REV.
C

AS9397™

RATIONALE

BOLT, TEE HEAD - CADMIUM PLATED,
STEEL, UNS G87400, 125 KSI MIN,
CHAMFERED, .1900-32 UNJF-3A

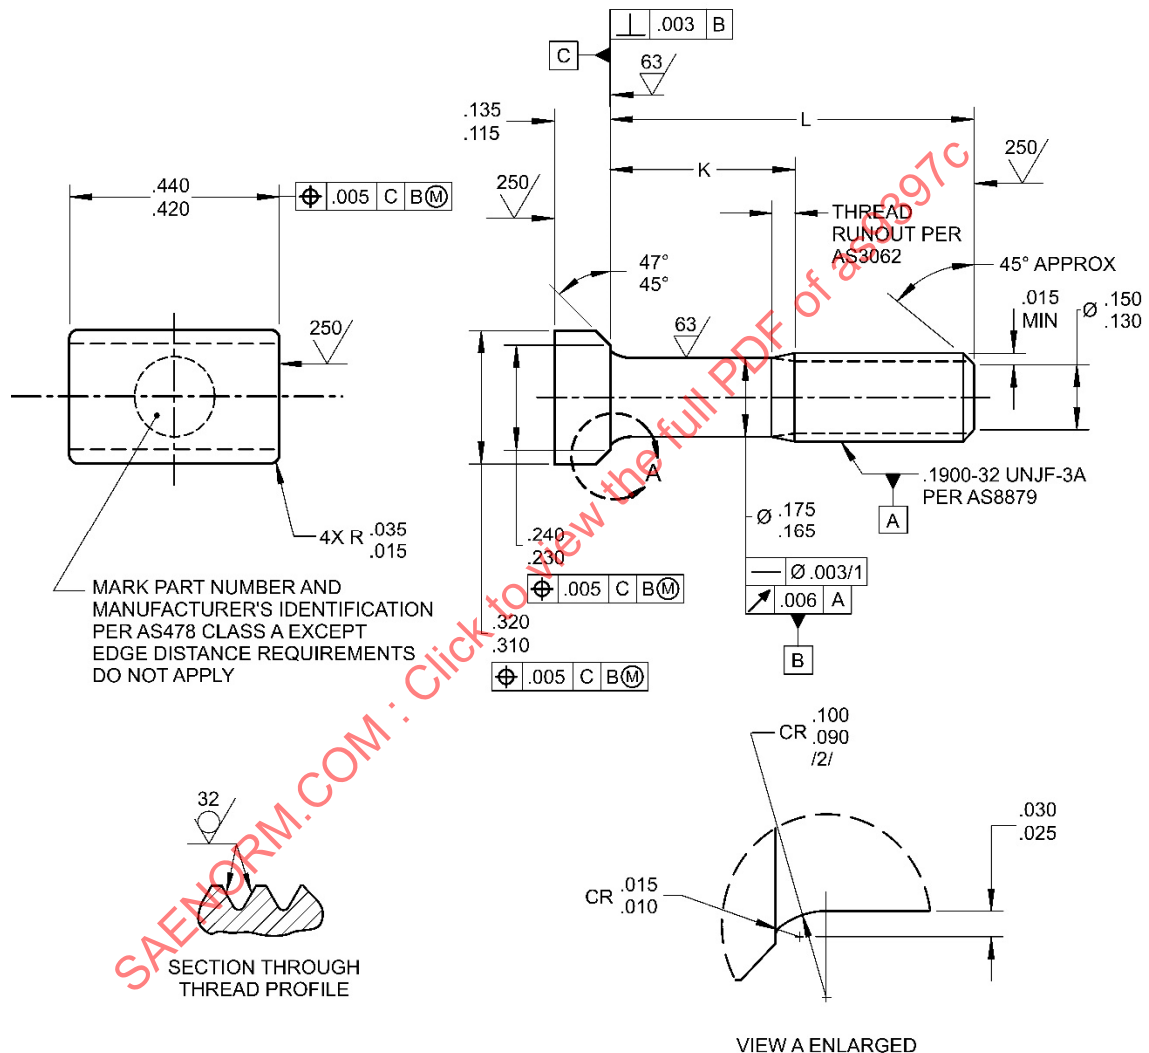
FIGURE 1 REDRAWN AND UPDATED TO ASME Y14.5-2018, REVISE LEAD THREAD CHAMFER TO AS1132, REVISE COMPOUND RADII CALLOUTS TO "CR" PER AS1132, GENERAL EDITORIAL UPDATES.
